CUSTOMER ADVISORY

ADV2002

Label Content Update for FPGA and Power Products

Table 2: Label Sample with “RoHS COMPLIANT”

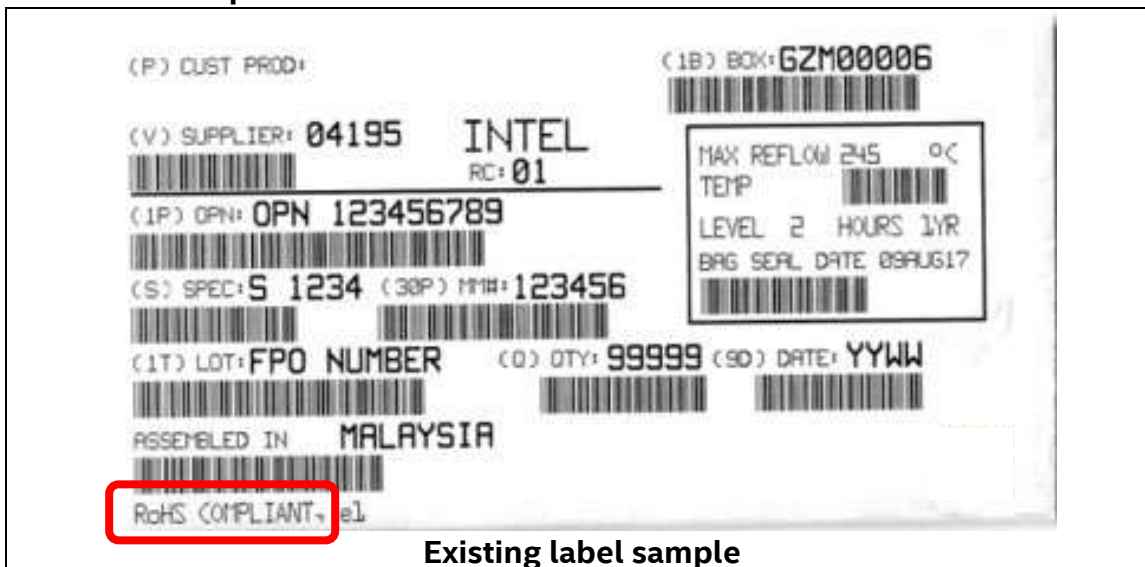
Change From	Change To
"RoHS COMPLIANT" indicated on the lower left of the barcode label	Labels may or may not indicate " RoHS COMPLIANT " on the barcode label. The 2nd level interconnect symbol (e.g. e1) remains printed on the label.

See next page Table 2 and Table 3 for sample labels.
